Loudoun County, Virginia

NOTICE TO BIDDERS

ADDENDUM NO. 4

The following changes and/or additions shall be made to the original Invitation for Bid (IFB) RFQ 372783 Loudoun County Metro Parking Garages Fare Collection & Improvements. Please acknowledge receipt of this addendum by signing and returning with your bid.

GENERAL NOTES:

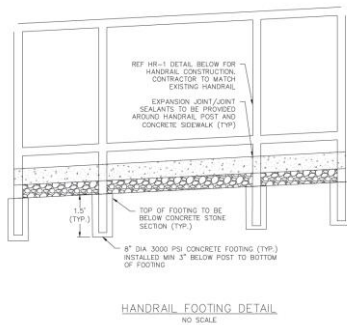
Q19: 03 000 Concrete: Confirm scope of work for 3rd party testing to be responsible by General contractor. See excerpt below

-----Drawing S102, General Note #2 "Prior to the start of construction, all areas designated for repair shall be sounded by the contractor in presence of engineer. All delaminated areas paint marked by contractor" < What is the additional extent of work from what is detailed within drawings? See cut photo from S103, general notes 1&2.

A19: The term "Engineer" on the drawings refers to the designated field representative of DESMAN; not the third-party testing agency. The scope of repair work is as indicated on the bid drawings; no additional work from what is detailed on the drawings is intended.

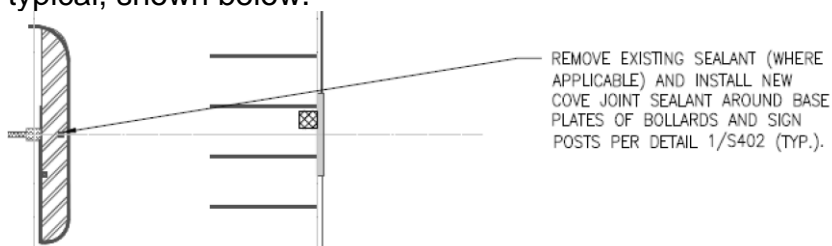
Q21: (05 000): Spec for handrail- Drawing CV05.0002, Detail shown below. Specification for handrail is not specified in detail.

Q22: (05 000): Detail for handrail installation shows railing mounted in footing, (Shown above); Existing railing is surface mounted- (Shown below) Please advise on configuration.

A21: Detail referenced HR-1 detail found on sheet CV05.0002 and shall be in accordance with the requirements of the VDOT Road and Bridge Specifications.

A22: Install as shown in detail with footing.

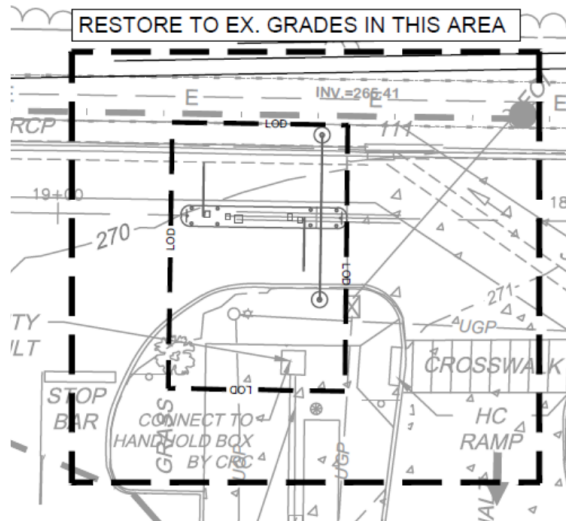
Q42: 26 000 Electrical: Will transformers or surge protectors of any kind be required?

A42: Transformers and/or surge protectors are not required, as noted in on the electrical drawings.
